SHOP DRAWINGS — ELECTRICAL / AGL SCOPE

RECTIFICATION OF TWY E BETWEEN E4 & E6 (ADIA)
AGL WORKS AT THREE (3) MILLING LOCATIONS — FIELD CONDITION SCOPE

Document No.	[XXX-ELE-SHD-1001 / 1002 / 1003] · Revision P06 (EDITABLE ISSUE)
Basis of scope	Field verification sheets: Document_3 (LOC-01) · Second_milling_area rev _1 (LOC-02/03) · Duct geometry: ADA drawing Z1-Z2-Z3-MTA_SEGMENTATION.dxf
Base layer	As-built AGL fitting positions: assets_20260726120533.xlsx — ZIA LOCAL PROJECT GRID (m). NOT UTM 40N; the Rev P05 EPSG:32640 label was incorrect — see sheet 6.
Prepared by	Mohammed — AGL Team Leader, ADB SAFEGATE AGL Team · Issued 28.07.2026

REV P06 — the "indicative duct" construction lines of Rev P05 (straight lines from each light to its nearest pit) are removed and replaced with the real as-built duct, ductbank, conduit and sawcut geometry from the ADA source drawing, registered onto each sheet to sub-millimetre. Every element remains a native editable PowerPoint shape. Provenance, registration residuals and limits: sheet 6.

LOCATION 1 — 1001 · REV P06 (EDITABLE)

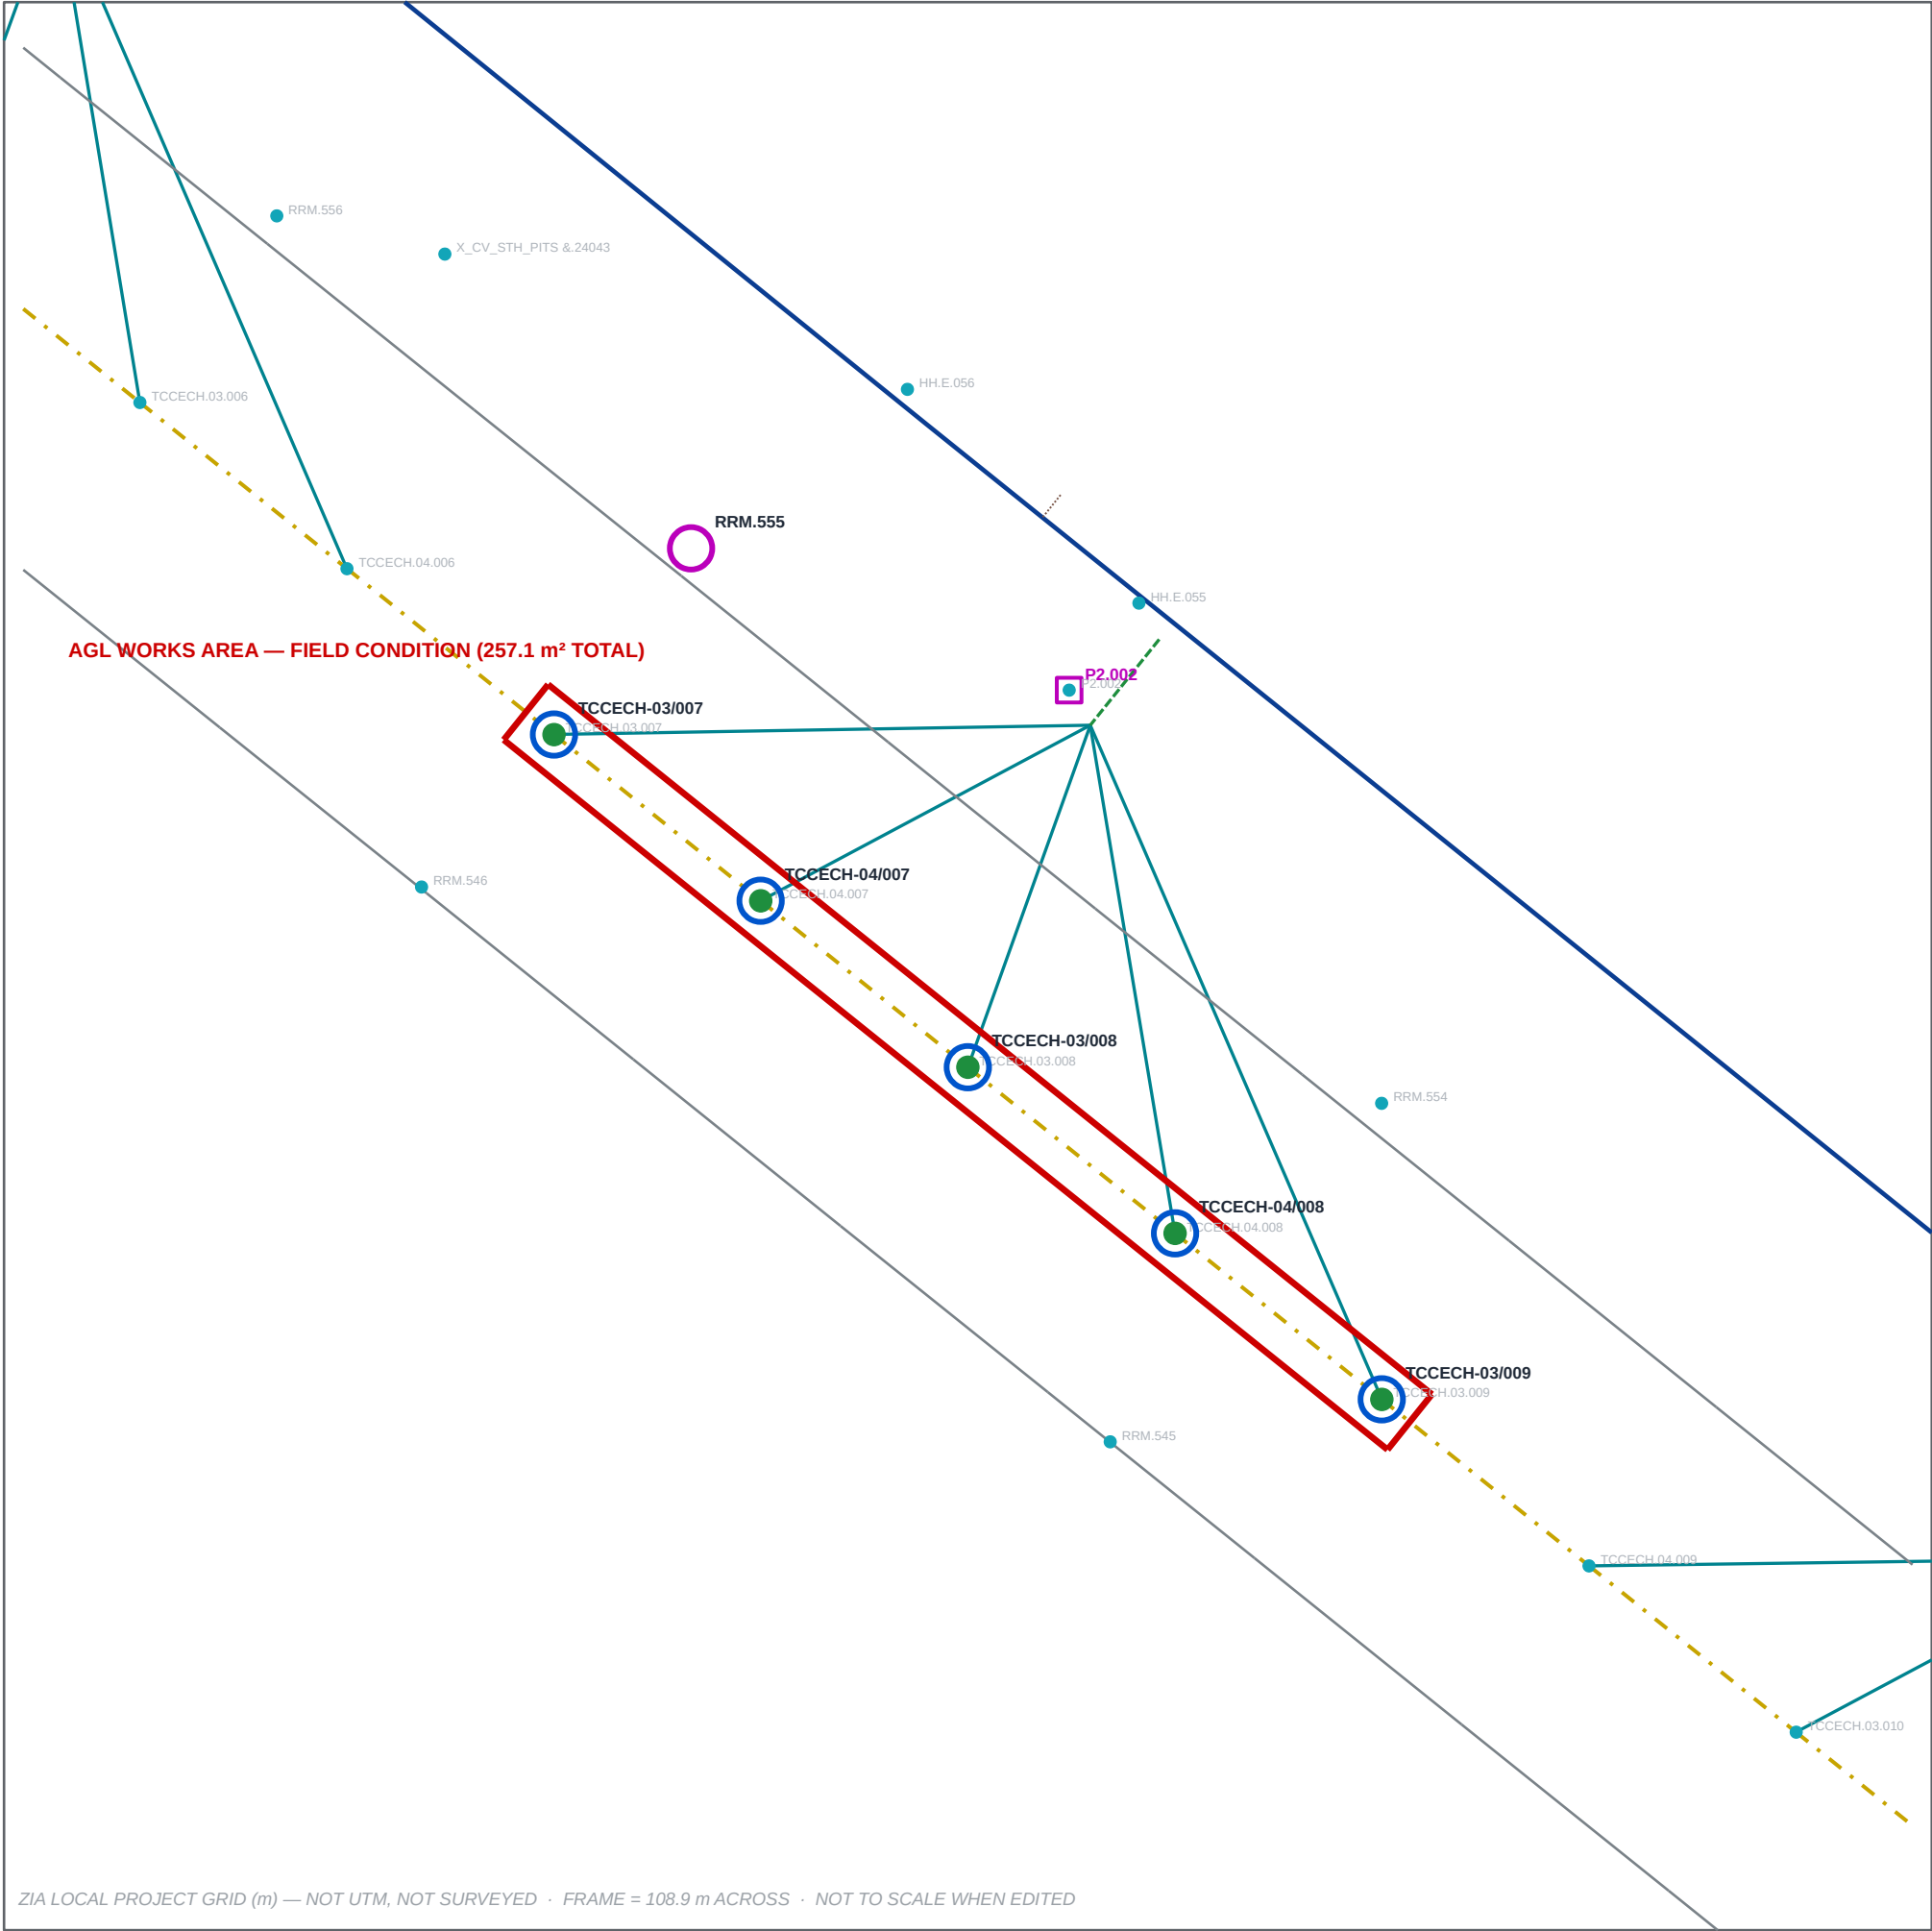
SCOPE / QUANTITIES (PER FIELD VERIFICATION)

CORE OUT SHALLOW BASE + NEW CABLE: 11 No.

- VIA DUCT (6): SBC102-02/024, 01/027, 02/025, 01/028, 02/026, 01/029
- VIA SAWCUT (5): TCCECH-04/034, 03/036, 04/035, 03/037, 04/036

NEW SECONDARY CABLE ONLY: 3 No

- SBC102-02/027 (DUCT) · TCCECH-03/035, 03/018 (SAWCUT — bases OK, verify at cut line)

FIELD VERIFIED NOT AFFECTED: SBC102-01/026 (no works)

ISOLATE CIRCUITS: SBC102.01/.02, TCCECH.03/.04

SITE RECORD 23.07.2026: 9 cored + 2 reinstatement already worked

1. Positions plotted are Z1 LOCAL PROJECT GRID metres — NOT UTM 40N. The Rev P06 "EPSG:32640" label was wrong; no surveyed local-to-UTM transform exists. Do not issue a UTM coordinate on this sheet.

LOCATION 2 — 1002 · REV P06 (EDITABLE)

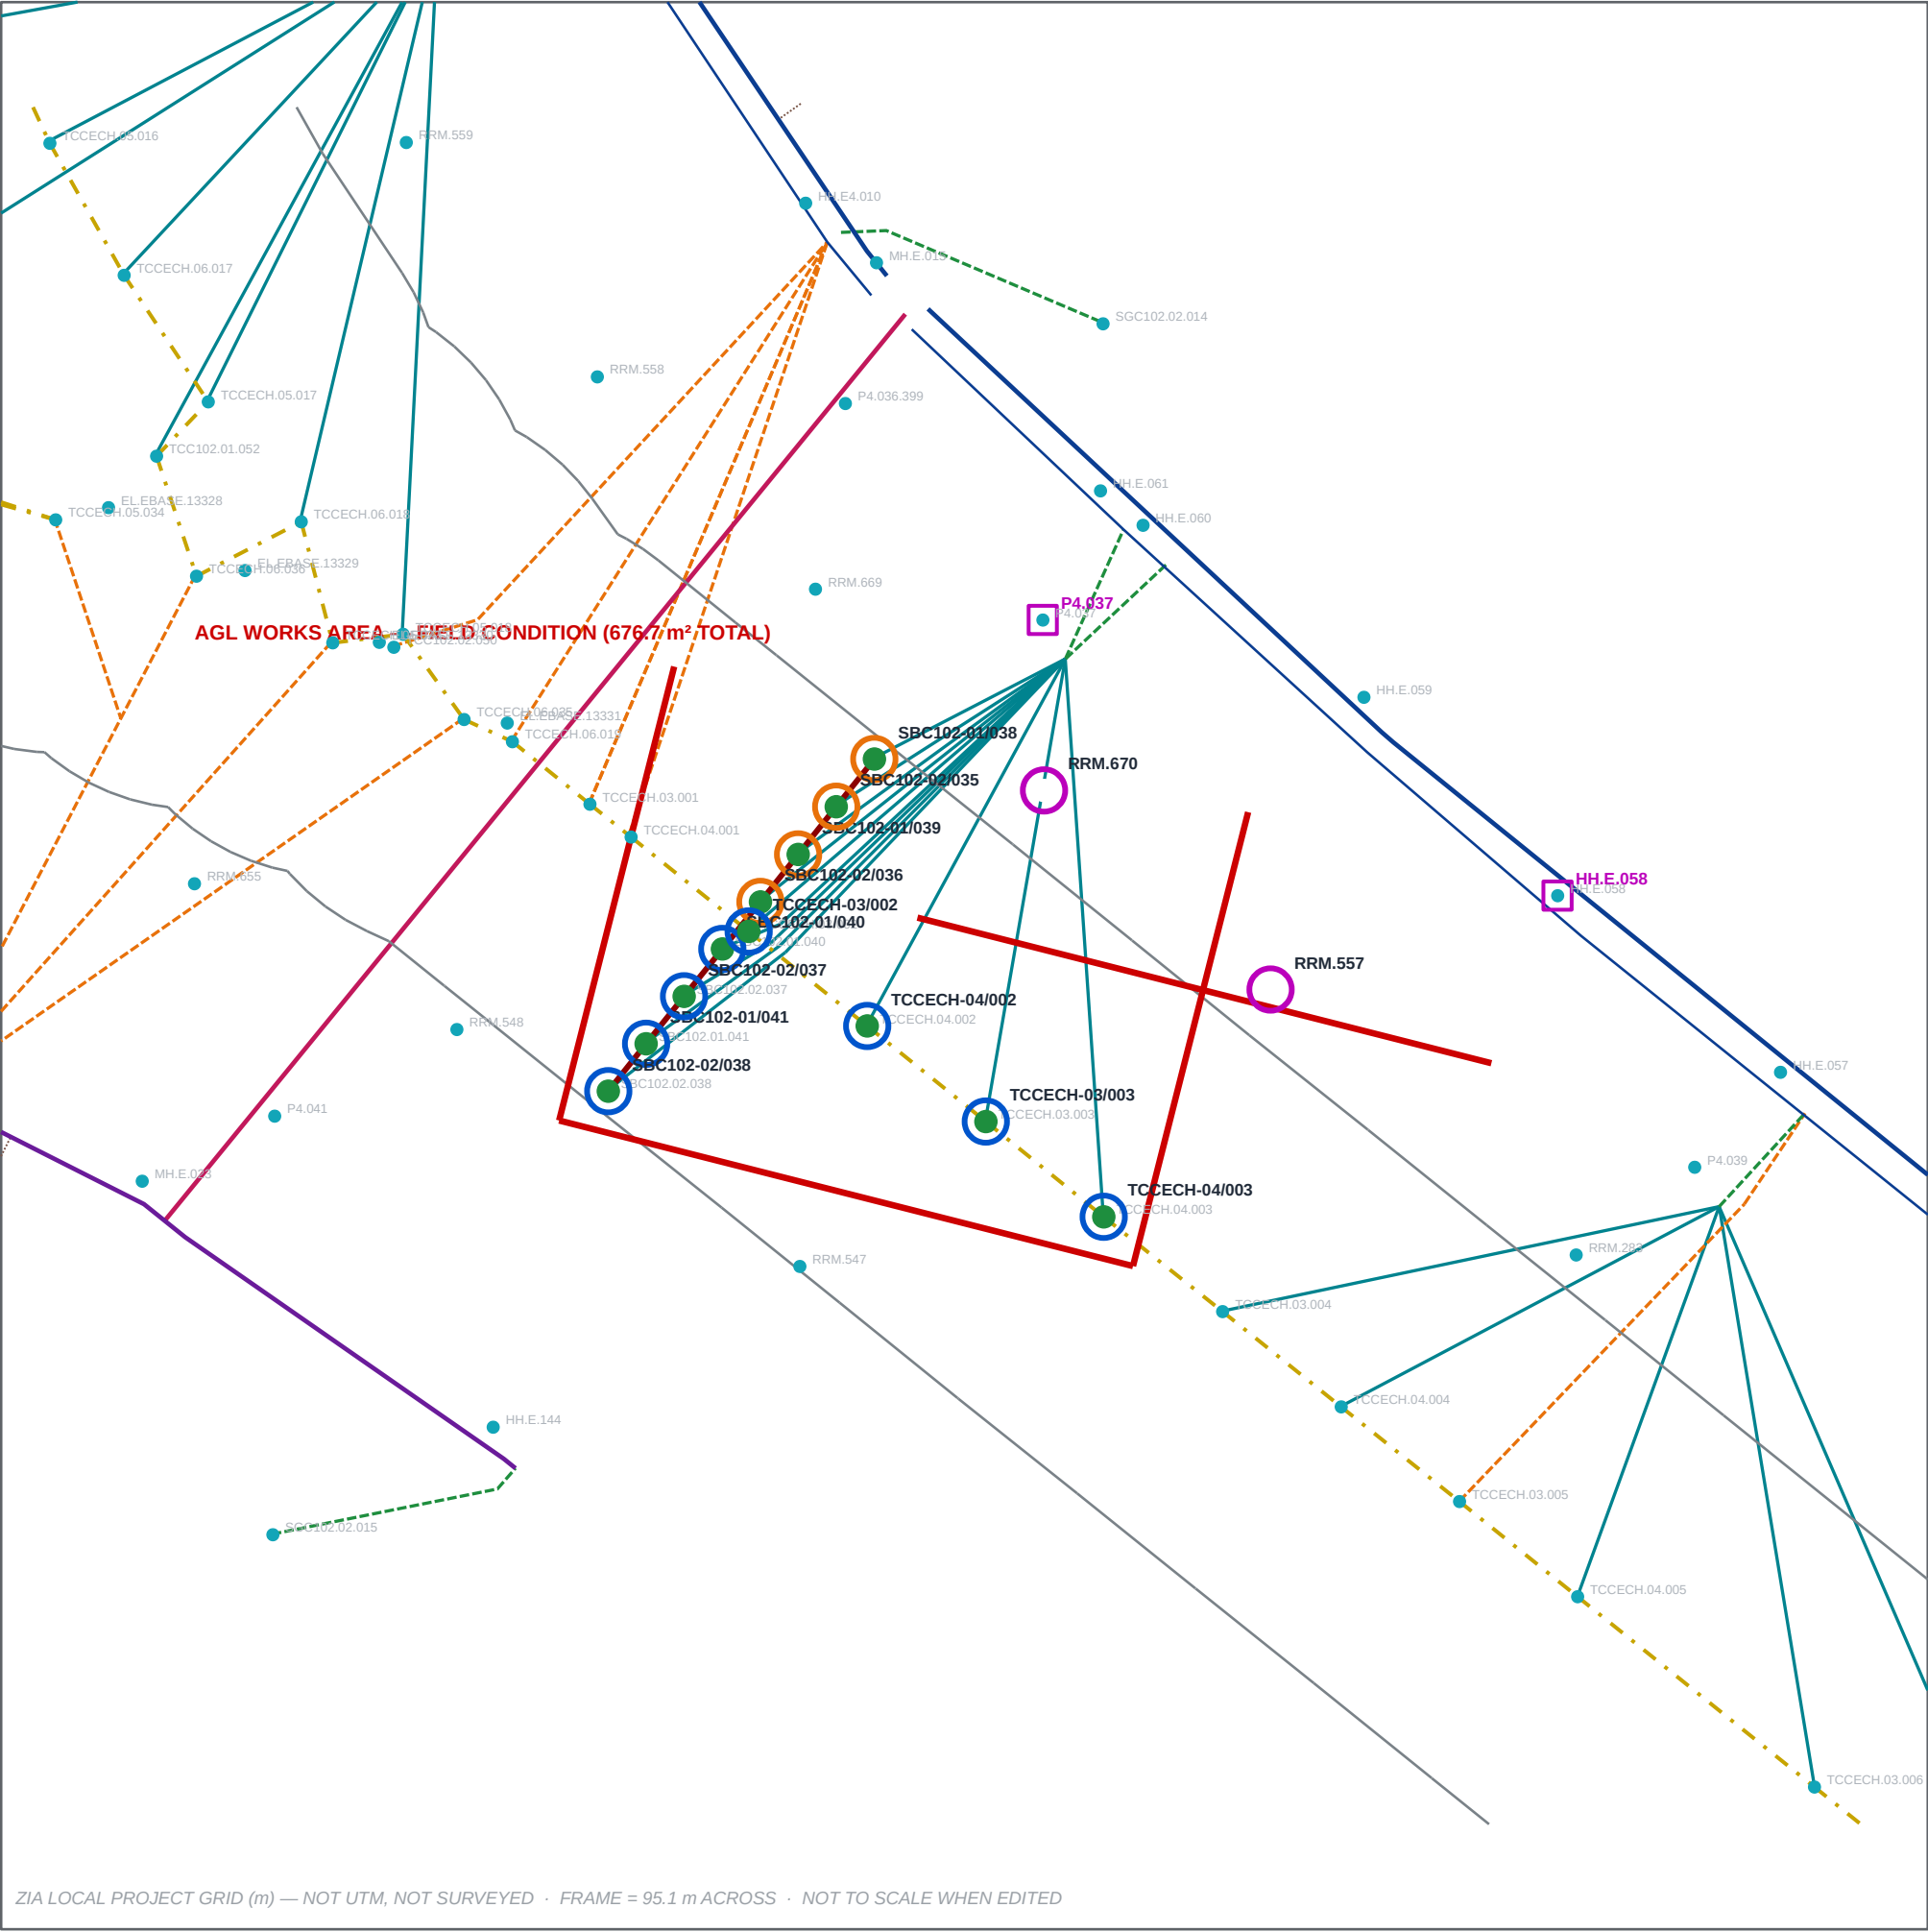
NEW SECONDARY CABLE ONLY (VIA DUCT): 5 No.
• TCCECH-03/007, 04/007, 03/008, 04/008, 03/009
NO SHALLOW BASES AFFECTED AT THIS LOCATION
SECONDARY DUCT: CHAINED RUN HH.E.056 → 03/007 → 04/007 → 03/008 → 04/008 → 03/009 → HH.E.054
+ SPUR FROM HH.E.055 — INDICATIVE, CONFIRM VS DUCT-LAYOUT CAD (REV B)
RRM.555 (0.41 m from cut): REMOVE / PROTECT BEFORE SAWCUT, RE-FIX AFTER PAVING
ISOLATE CIRCUITS: TCCECH.03, TCCECH.04

- Positions plotted are ZIA LOCAL PROJECT GRID metres — NOT UTM 40N. The Rev P06 "EPSG:32640" label was wrong; no surveyed local-to-UTM transform exists. Do not issue a UTM coordinate from this sheet.

SHEET 6 — DUCT PROVENANCE & REGISTRATION VERIFICATION · TWY E (E4-E6) REV P06

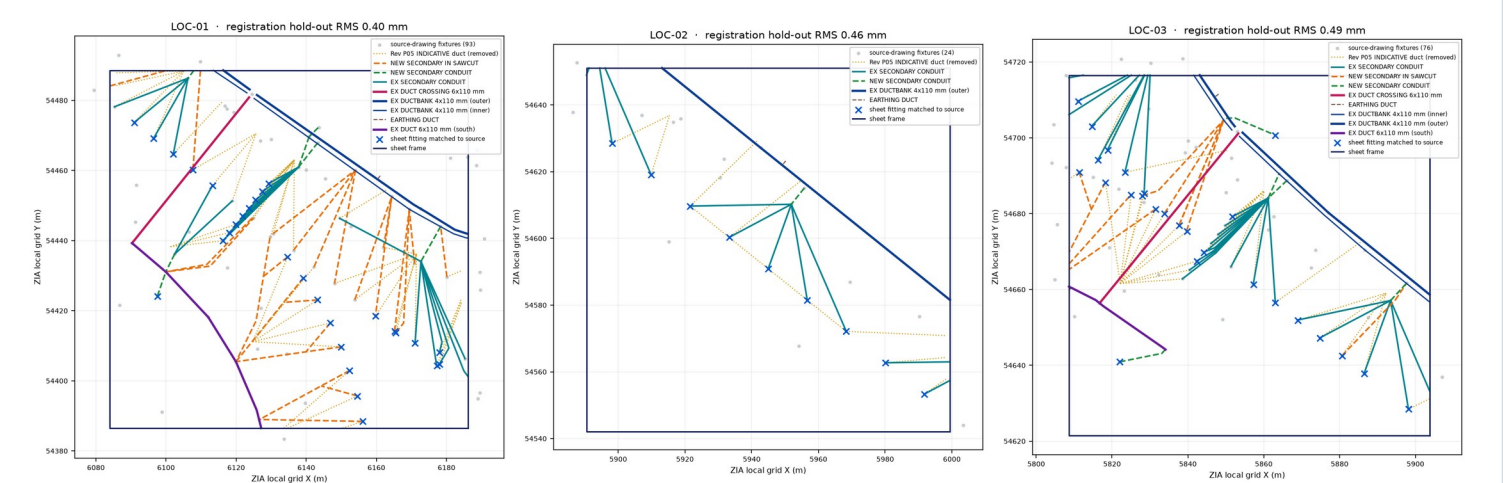
3 · FINDING — THE Rev P05 COORDINATE LABEL WAS WRONG

Rev P05 sheets state "UTM 40N (EPSG:32640) — AS-BUILT POSITIONS". They are not UTM. The plotted positions are ZIA local project grid metres (X ≈ 5,800–6,200, Y ≈ 54,400–54,700). UTM 40N here would read easting ~230,000–800,000 and northing ~2,650,000–2,750,000.
The source drawing carries no GEODATA object and no georeferencing of any kind, so no local→UTM transform can be derived from it. Rev P06 sheets are relabelled accordingly.
Consequence: any coordinate previously issued from Rev P05 as UTM — to ADA, Injaz or a contractor — needs withdrawing and re-checking against survey control.

5 · LIMITS — READ BEFORE USING THIS GEOMETRY

- a) Runs are fragments, not proven pulls. The duct lines are the individual LINE / LWPOLYLINE segments as drafted. No endpoint snapping or graph chaining has been done, so "handhole A to handhole B" is not established. Do not order cable to a length scaled off these sheets.

- b) Coordinates are ZIA local grid, not surveyed and not UTM. Nothing here may be issued as a setting-out coordinate without an externally checked transform against ADA survey control.

- c) Civil symbols are ~2.1–2.3 m off. Handhole, manhole, transformer-pit and RRM symbols on the sheets sit a mean 2.1–2.3 m (sd 0.3–0.45 m) from the source-drawing insertion point, while AGL light fittings match to sub-millimetre. Set out civil features from survey, not from these sheets.

- d) Per-asset route attribution is NOT given. The consolidated table's "Route" column is unchanged from Rev P05. Attributing a specific duct layer to a named asset was attempted and rejected: the sheets' labels sit 3–8 m from their markers with neighbours only 10–15% further, and several markers resolve to the same label, so the assignment cannot be made from the drawing alone. It needs the source asset register, which is not in this data set.
